MY23 C-Class (206 platform)	·	
RE: Service Campaign Launch Notification Install Rivets on Cross-member above Rear Axle	DATE: June 30, 2023	
Sales Managers, Service Managers, Parts Managers	Compliance and Analysis, Engineering Services	
TO: Mercedes-Benz Dealer Principals, General Managers,	FROM: Gregory Gunther, Department Manager, Vehicle

Campaign No. 2023060008, June 2023

Install Rivets on Cross-member above Rear Axle

Figure 1

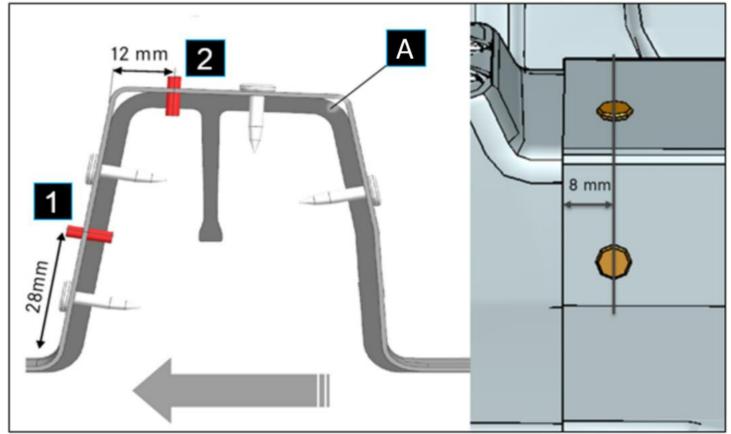
- 1. Remove rear seat cushion padding.
  - i For basic information, see: AR91.12-P-1022WT.
- 2. Remove seat backrest in rear passenger compartment completely.
  - For basic information, see: AR91.12-P-1713WT (except code 287 (Through-loading feature)).
  - For basic information, see: AR91.12-P-1723WT (with code 287 (Through-loading feature)).
- 3. Remove trunk lining.
  - I For basic information, see: AR68.30-P-4602WT (except code ME10 (Hybrid vehicle (plug-in, PHEV)).
  - For basic information, see: AR68.80-P-6000WT (with code ME10 (Hybrid vehicle (plug-in, PHEV)).
- **4.** Perform power disconnect for high-voltage on-board electrical system.
  - i For basic information, see: AR47.70-P-1010AMC (with code ME10 (Hybrid vehicle (plug-in, PHEV)).
- 5. Mark rivet holes on cross-member (A, Figure 1).
  - i Mark positions 1 and 2.

Figure 2

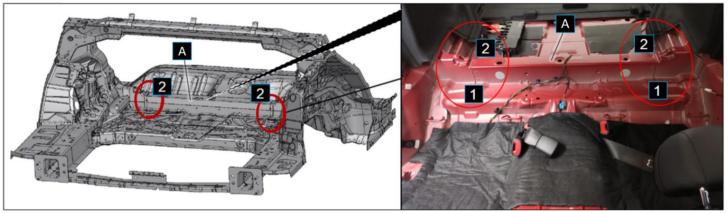
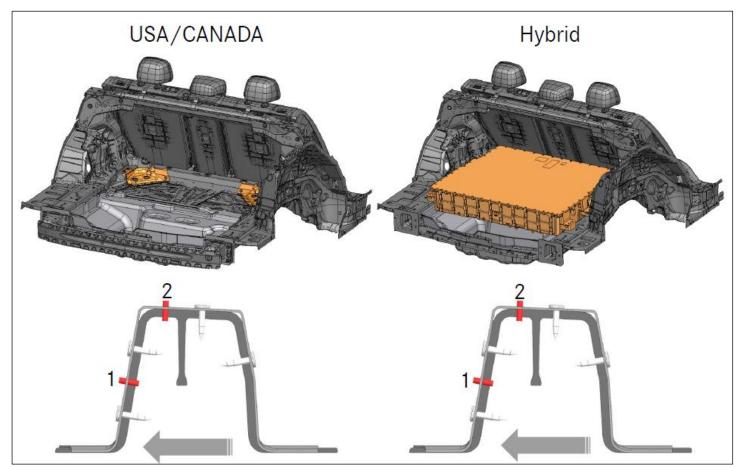
- 8. Rivet cross-member (A, Figure 2) with riveting machine at positions 1 and 2 (Figure 2 and 3).
  - i Riveting tool with a pulling force greater than 19kN as per rivet specification is needed.
  - i Dip each rivet into primer first.
    - **a.** Use 6.5 mm x 14.5 mm rivets (A 004 990 17 97) in positions 1.
    - **b.** Use 6.5 mm x 12.5 mm rivets (A 004 990 16 97) in positions 2.
